ADDENDUM #1

Project Name: GRC Kitchen Tunnel Repair
DAS #9018.00
RFB #0919335025
Dated: October 25, 2018

D. M1.0 – Tunnel Floor Plan – Mechanical

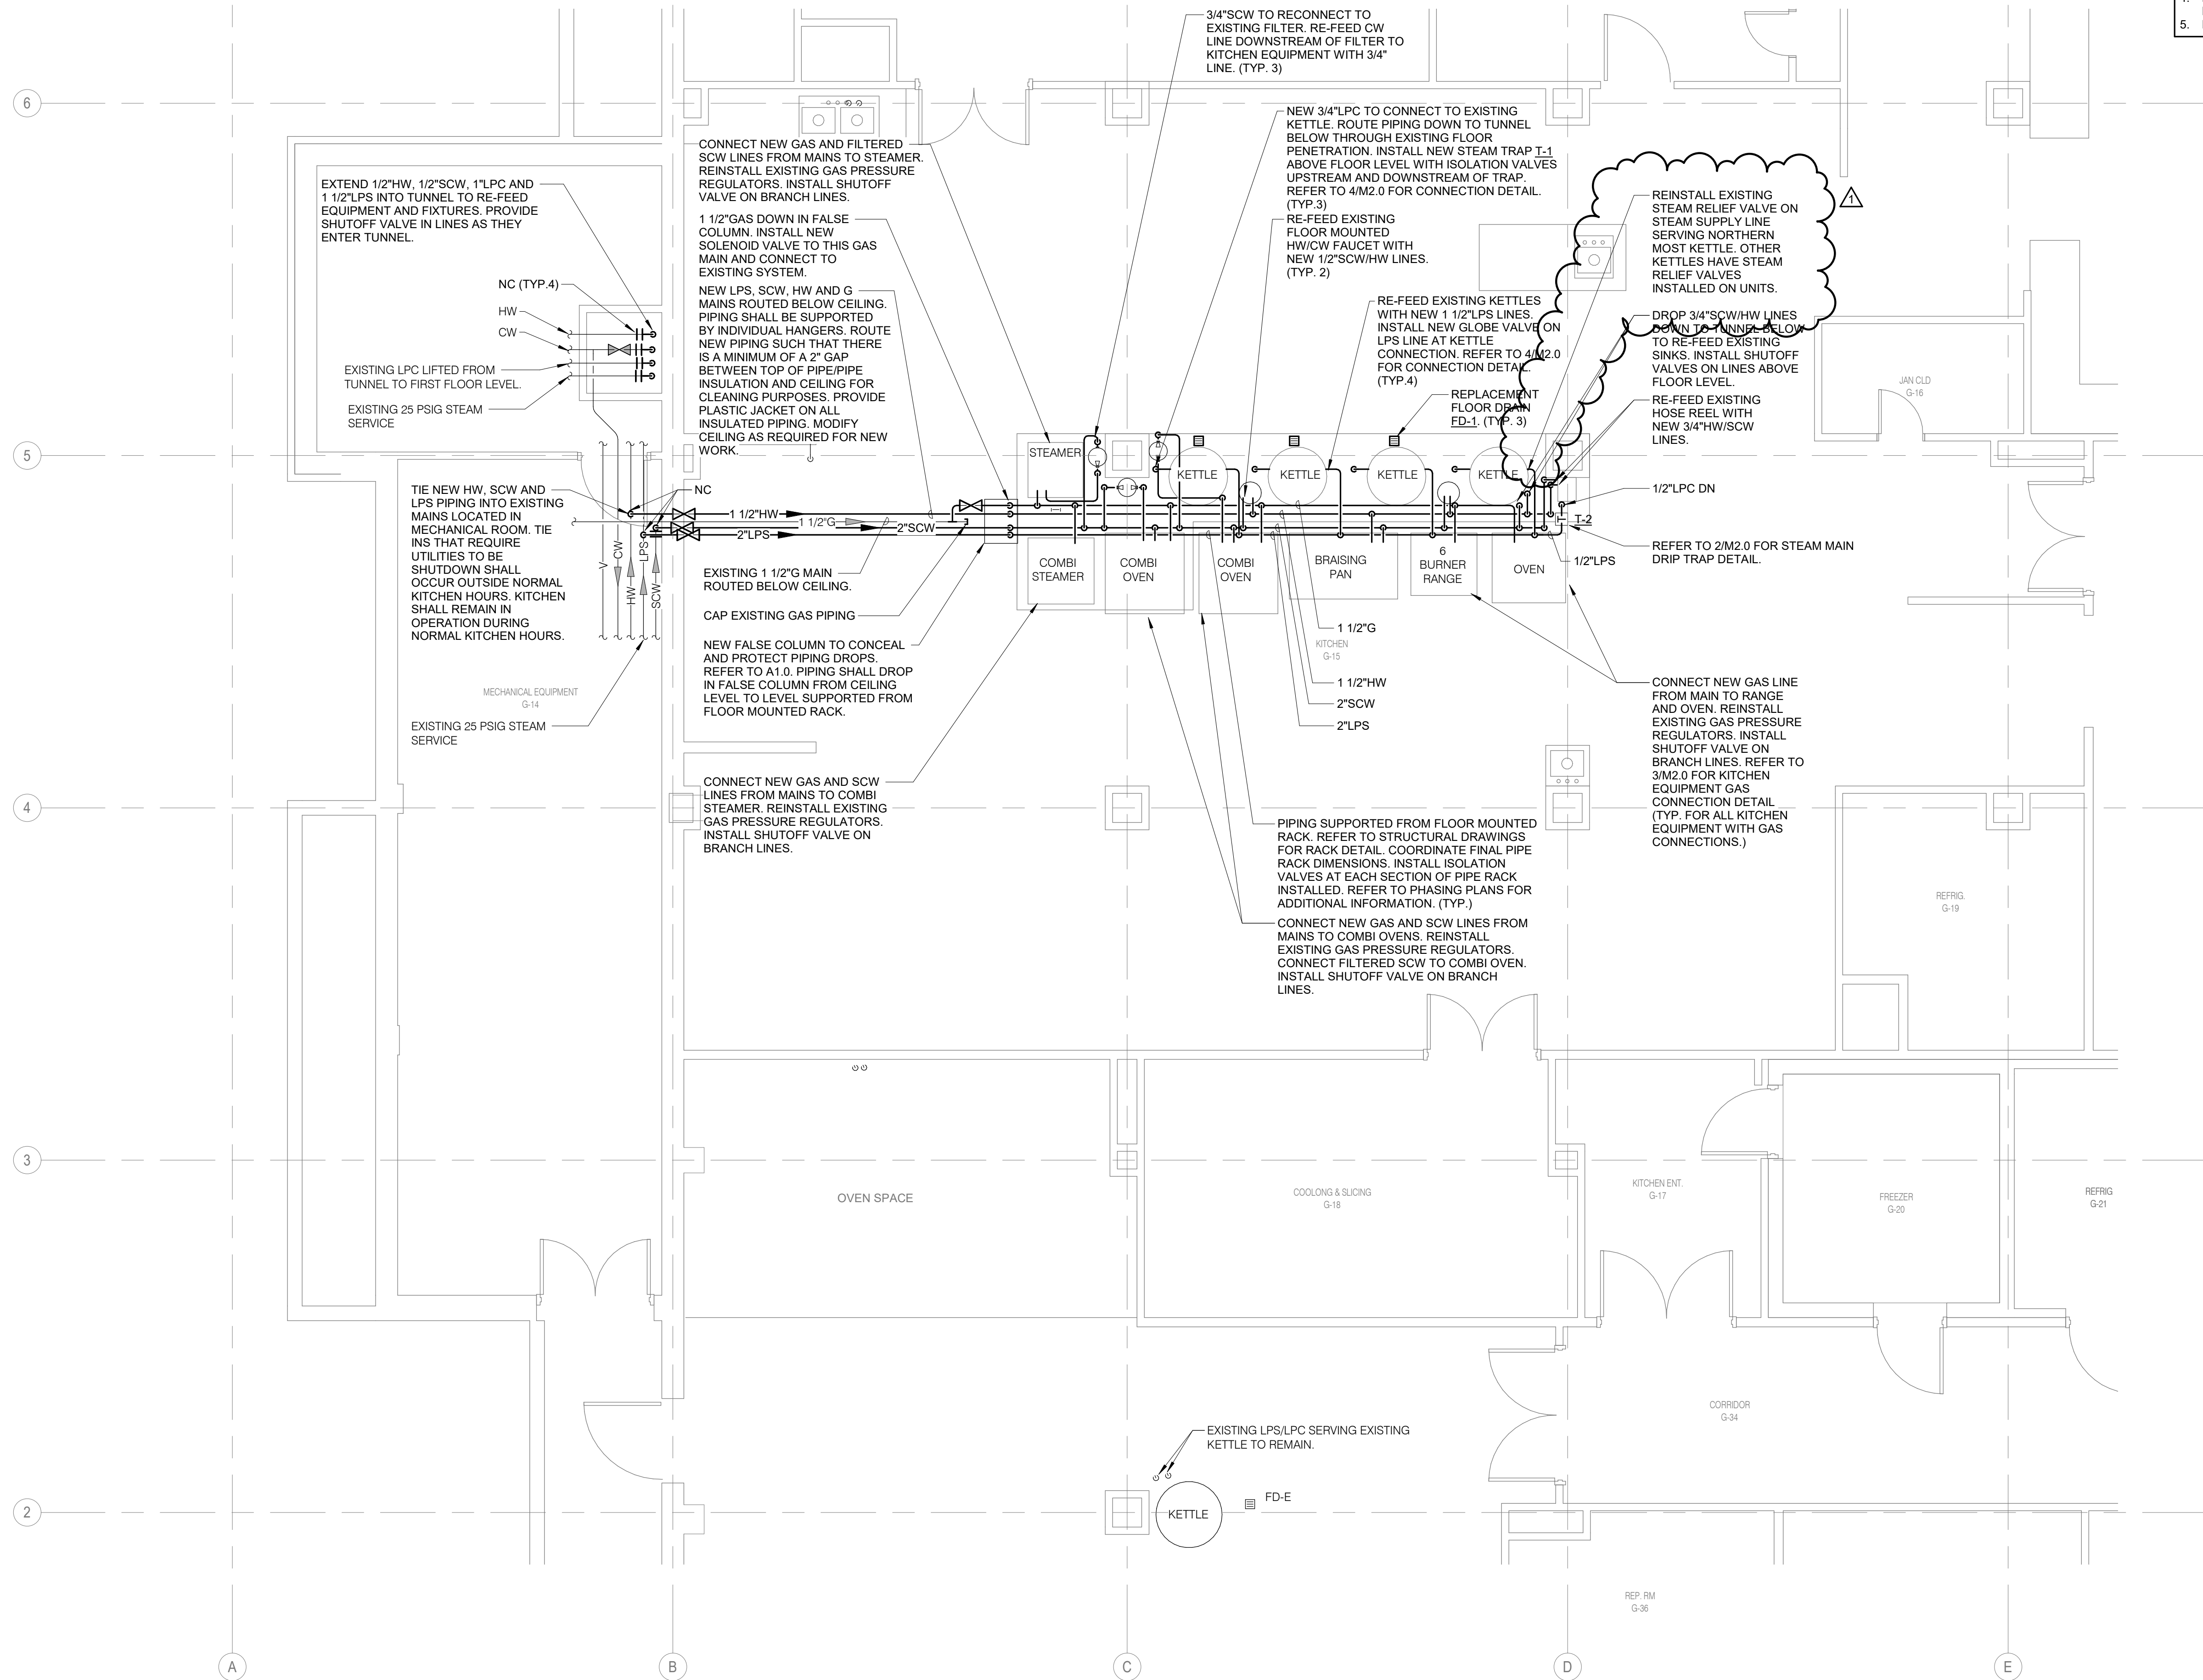
1. **ADD** an existing 2" sanitary drain line in the tunnel that is to remain. Refer to revised sheet M1.0 attached.
